Link Auxiliary Axle Hardware, Retorque
CXU, AN

PI0888, Link Auxiliary Axle Hardware, Retorque

(July 2019)

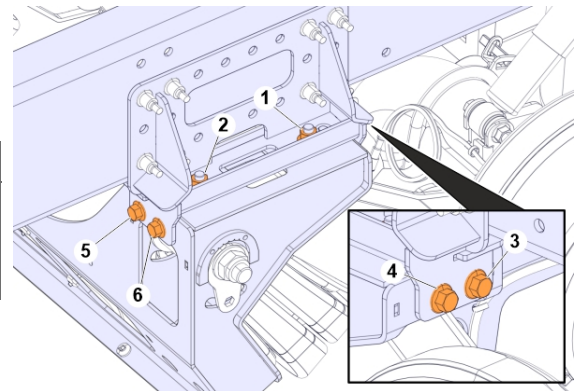
6. Torque tighten the screws and nuts.

Tightening torque	
Fasteners	Tightening sequence: 1-6
	305 \pm $\frac{14}{34}$ Nm (225 \pm $\frac{10}{25}$ lb _r -ft)

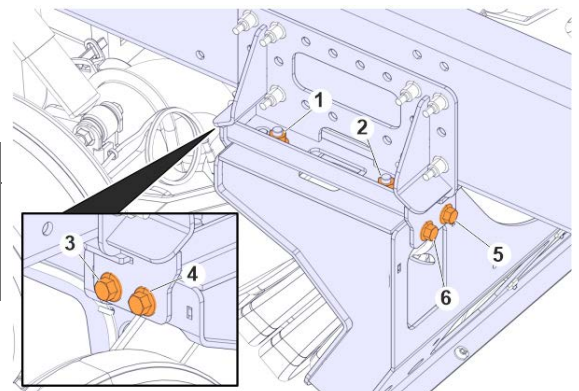
7. Torque tighten the screws and nuts.

Tightening torque	
Fasteners	Tightening sequence: 1-6
	305 \pm $\frac{14}{34}$ Nm (225 \pm $\frac{10}{25}$ lb _r -ft)
